# UNITED STATES PATENT AND TRADEMARK OFFICE

APPLICATION NO.	FILING DATE	FIRST NAMED INVENTOR	ATTORNEY DOCKET NO.	CONFIRMATION NO.
10/031,637	12/19/2001	Michael Birsha Davies	PG3693USW	4268

**Office Action Summary**

## DETAILED ACTION

Prior Art  
figure 3  
Groves US 3,492,733

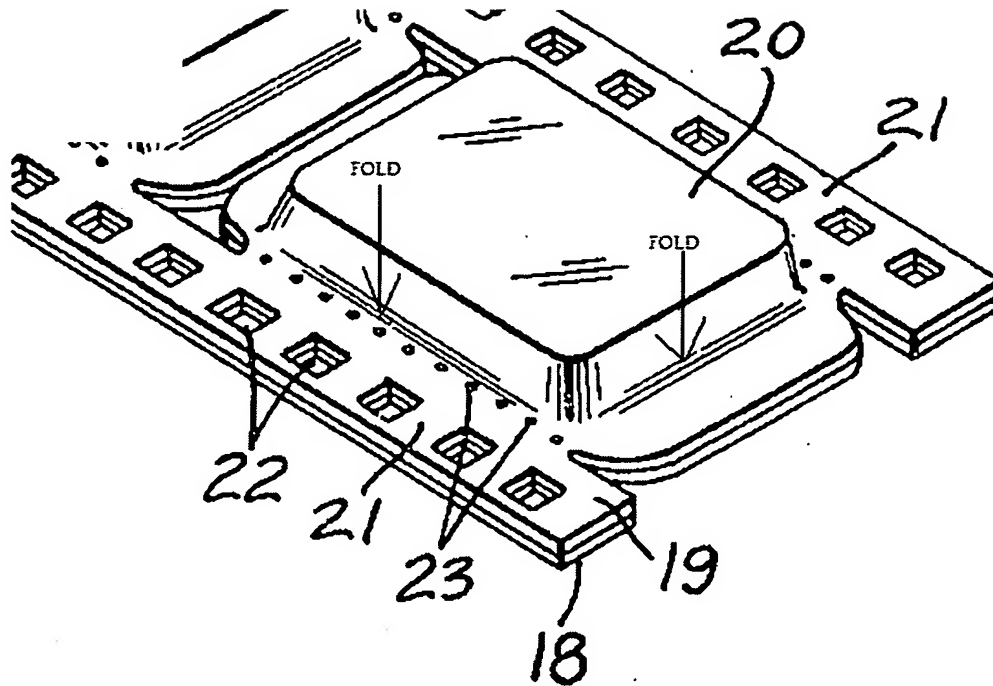
**As to claim 1**, Groves discloses a carrier comprising an elongate strip (fig.3, 24,25) having a first portion (24) and a second portion (25), a fold (see labeled fig.3 attached below) between said first portion and said second portion such that the first portion contacts the second portion (see fig.3); and a join (see "seal", col.3 lines 71 and 72) between the first portion and the second portion, wherein said join and the fold form the edges of a pocket or pouch (fig.3, 20) for containment of medicament, said pocket or pouch containing a unit dose of medicament (fig.2, 16) therein and, wherein the ends of the elongate strip form a pair of pull release tabs (fig.3, 18,19, see also col.1 lines 20-24), each of said release tabs having at least one perforation (22,23,

**As to claim 16,** Groves discloses a carrier according to claim 1 comprising a series arrangement of a plurality of carriers (see fig.3).

**As to claim 17,** Groves discloses wherein each of said plurality of carriers is connected together (see fig.3).

**As to claim 18,** Groves discloses wherein each of said plurality of carriers is formable from the same elongate strip (see fig.3).

**As to claim 19,** Groves discloses wherein said strip has a point of weakness (see labeled fig.3) between each carrier in said series arrangement.
